R66 SERVICE BULLETIN SB-04

SUBJECT: Oil Cooling Fan Inlet Clearance

ROTORCRAFT AFFECTED: R66 helicopters S/N 0004 thru 0061, 0063 thru 0074, 0076 thru 0080, 0082 thru 0096, 0098, 0100, 0102 thru 0107, 0110, 0111, 0113, 0115, 0117, and 0121.

FIGURE 1

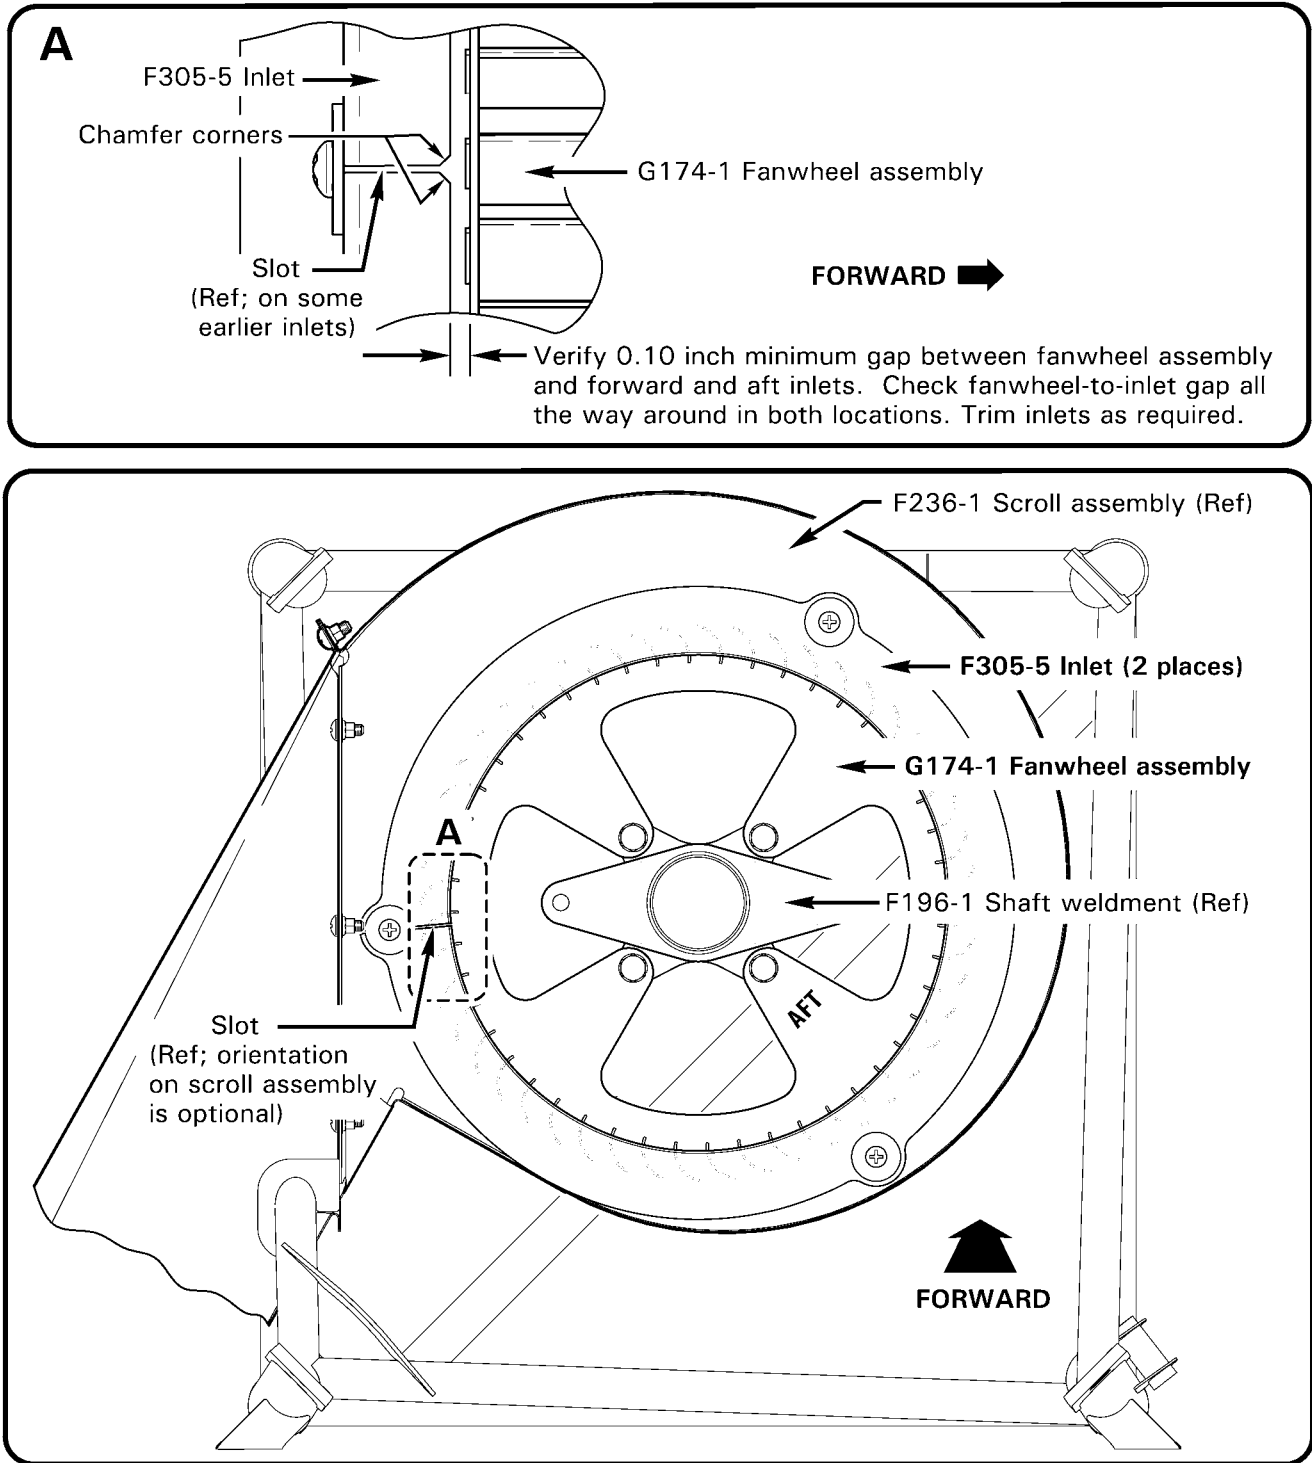
BACKGROUND: RHC received an engine cooling fanwheel that separated from the fan shaft during flight. The fanwheel's ring plates were worn due to rubbing against the scroll inlets. This bulletin requires trimming inlets as necessary to ensure a sufficient fanwheel-to-inlet gap.

1. Remove tailcone cowling per R66 Maintenance Manual (MM) § 53-23.
2. Refer to Figure 1. Verify 0.10 inch minimum gap between G174-1 fanwheel assembly and forward and aft F305-5 inlets. Check gap all the way around; rotate fanwheel and check gap again (several positions). If gap is within limits at forward and aft inlets, proceed to step 7.

3. Remove hardware securing inlet(s) to F236-1 scroll assembly. If inlets are slotted, carefully twist inlets over F196-1 fan shaft to remove them. If inlets are not slotted, cut slot in inlets using tin snips per Figure 1 (it is not necessary to disconnect drive train). Straighten part as required. Chamfer slot corners near radius as shown.

4. Refer to MM § 20-70. Trim inlets as necessary to meet minimum fanwheel-to-inlet gap. Smooth inlet edges, deburr new slot edges, and coat bare metal with primer. Touch-up primed area using dark gray polyurethane enamel in accordance with paint manufacturer's recommendations.

5. Carefully twist inlets over fan shaft (slot orientation after installation is not critical). Install hardware securing inlets to scroll. Verify security.

6. Measure fanwheel-to-inlet gap per step 2. Repeat procedure as required for minimum 0.10 inch gap at forward and aft inlets.
7. Install tailcone cowling per MM § 53-23.
